**Report: TAB Report**  
**Function: Test, Adjust, & Balance**  
**Date: 01/18/2026**  
**Completed By: National TAB**

**Fieldstone @ Chester Springs ALF (Chester Springs, PA)**

## Issue List

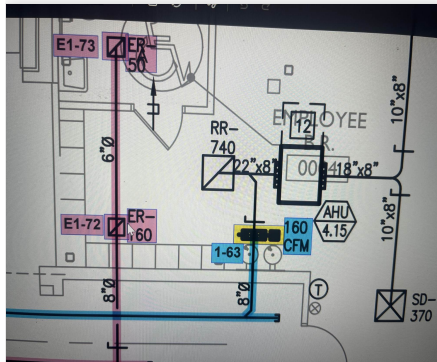
**Issue Name :** Basement exhaust fire damper  
**Description :** There is a drop off in flow from the first floor exhaust duct down to the basement, branch dampers on the first floor and basement confirmed full open. The fire damper was inspected and confirmed fully open, but there is audible turbulence and the damper is internal to the duct and looks to be taking up 35-40% of the duct flow area.  
**Created By :** National TAB                      **Assigned To :** National TAB - Tyler Youells  
**Status :** Open  
**Priority :** High                                      **Asset Tag :**  
**Originated Date :** 01/28/2026 - Tyler Youells - National TAB

- **01/28/2026 National TAB - Tyler Youells**
  - Suspect the fire damper is the cause of low exhaust flow on the first floor and recommend upsizing damper size.

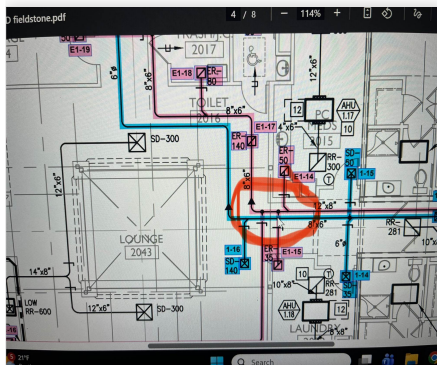
**Issue Name :** Locker room exhaust E1-72  
**Description :** Exhaust register E 1-72 serving the locker room is installed as a 6" neck for 160CFM, Basement exhaust is already low but this exhaust register is at 22cfm. recommend upsizing the duct to 8" to allow for more flow.  
**Created By :** National TAB                      **Assigned To :** National TAB - Tyler Youells  
**Status :** Open  
**Priority :** Medium                                      **Asset Tag :**  
**Originated Date :** 01/28/2026 - Tyler Youells - National TAB
